|  SYMBOL OF QUALITY AN ISO 9001 COMPANY | | JINDAL ALUMINIUM LTD. BANGALORE-560073 (INDIA) | | DRAWN | NAME | DATE |
| ALLOY & TEMPER 6063 T6 | | DESCRIPTION NOSE PROFILE | | P-14219 E0225 E0225(ISSUE-2) | | |

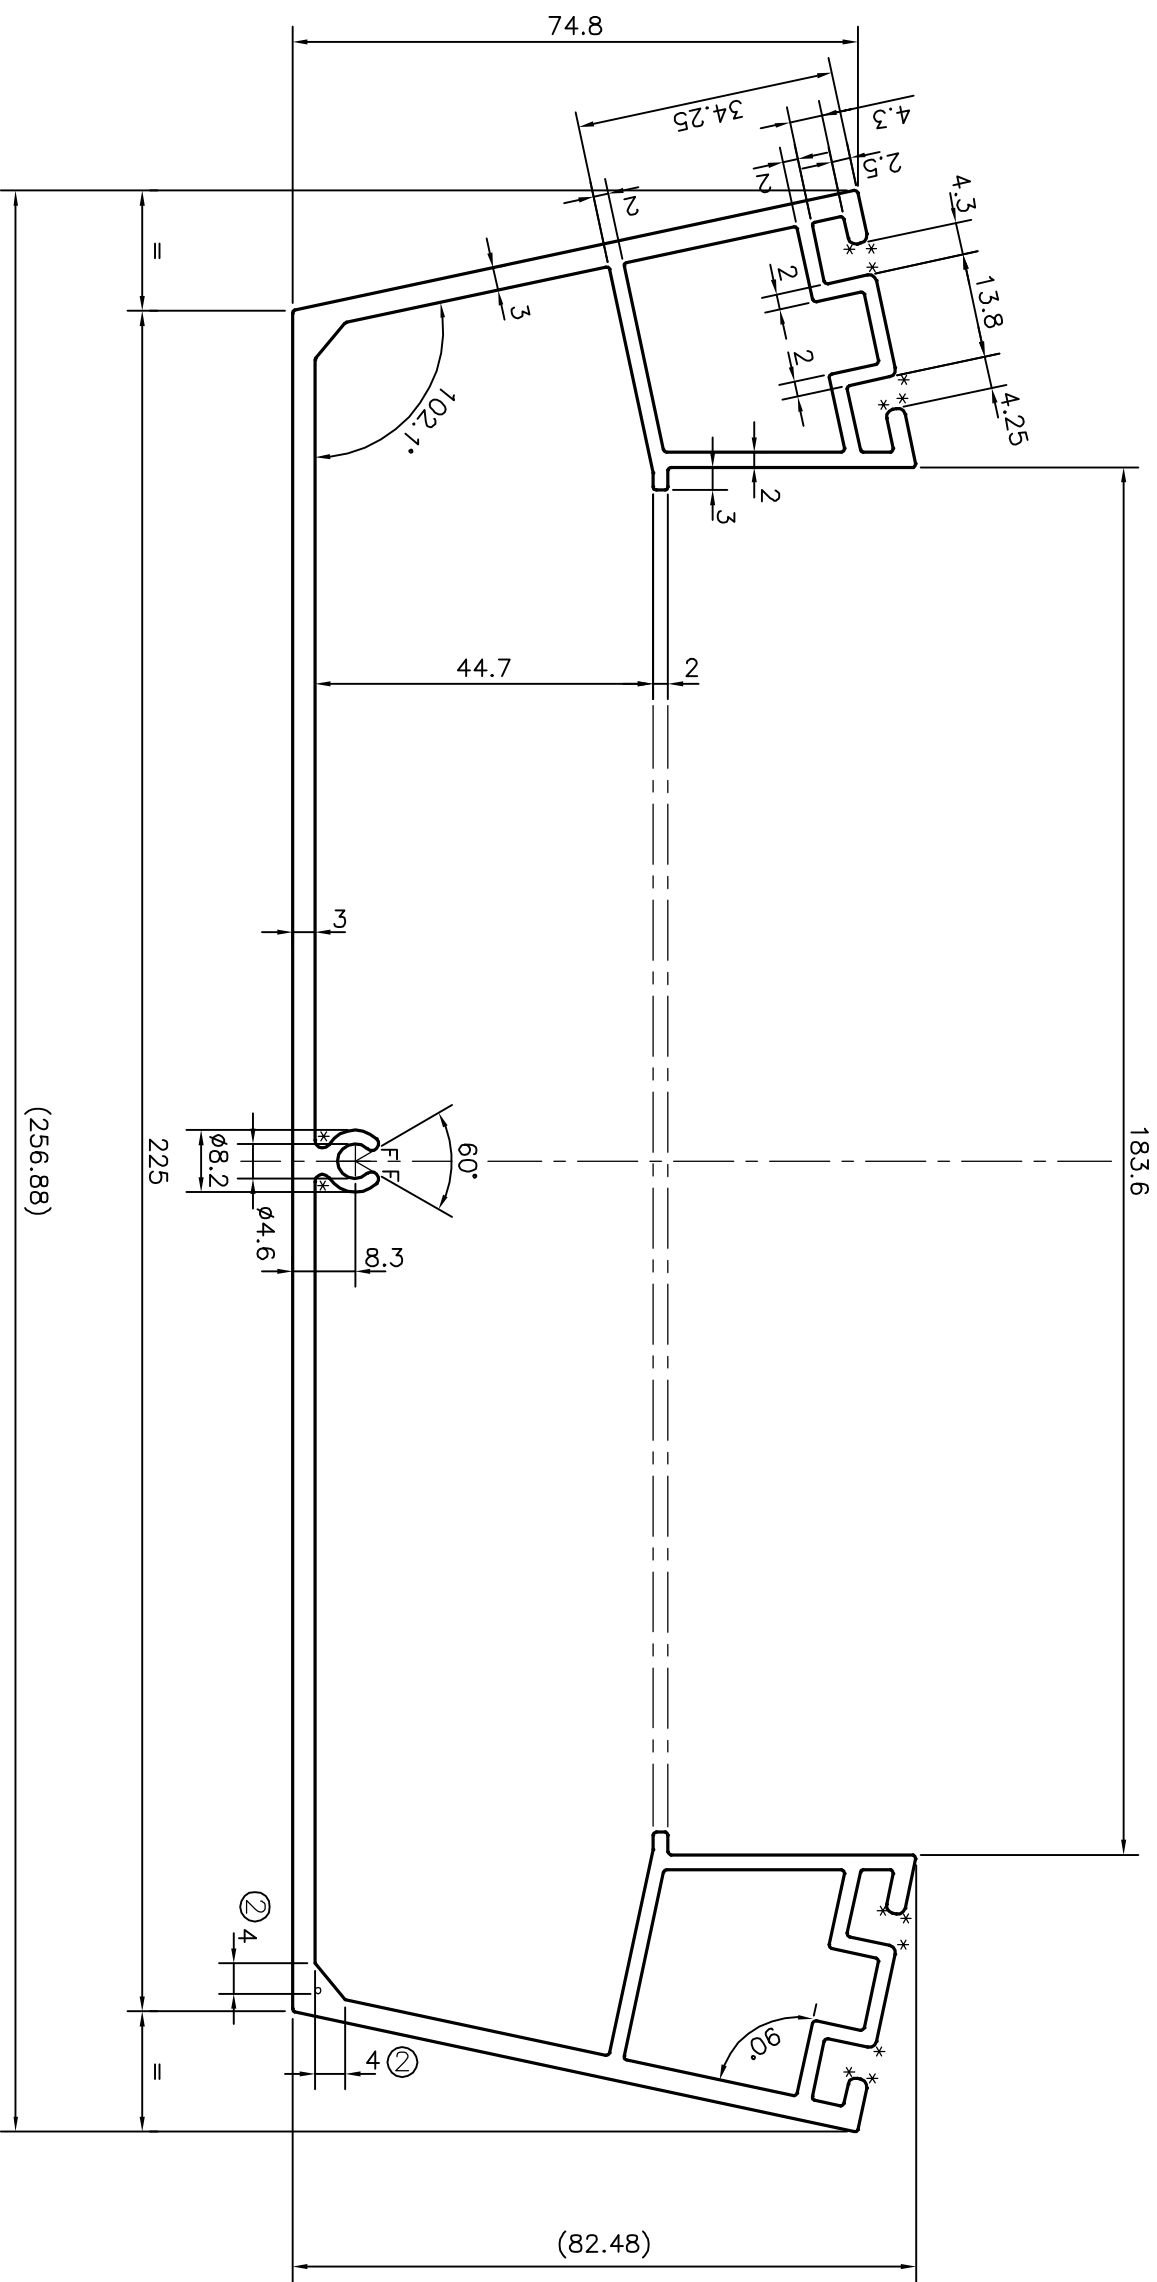
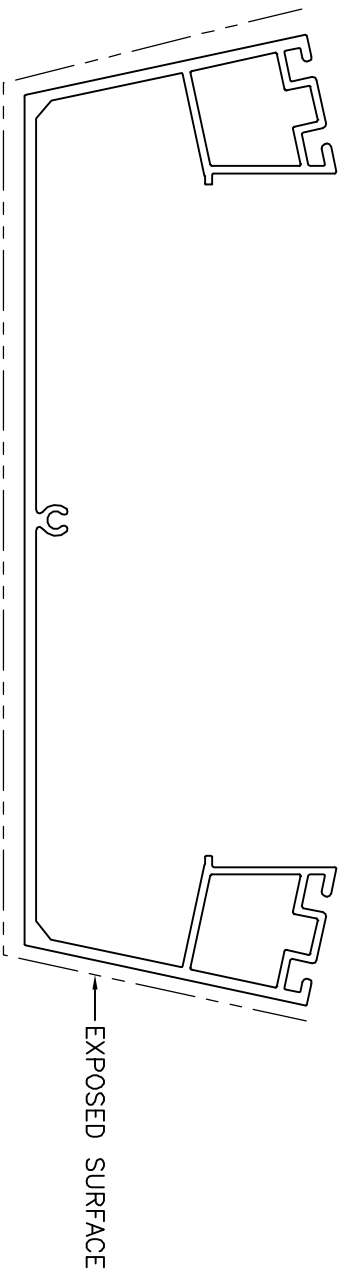
ISSUE-2
 CHAMFER 4x4 ADDED
 WEIGHT ALSO CHANGED FROM 4.407 kg/m TO 4.449 kg/m
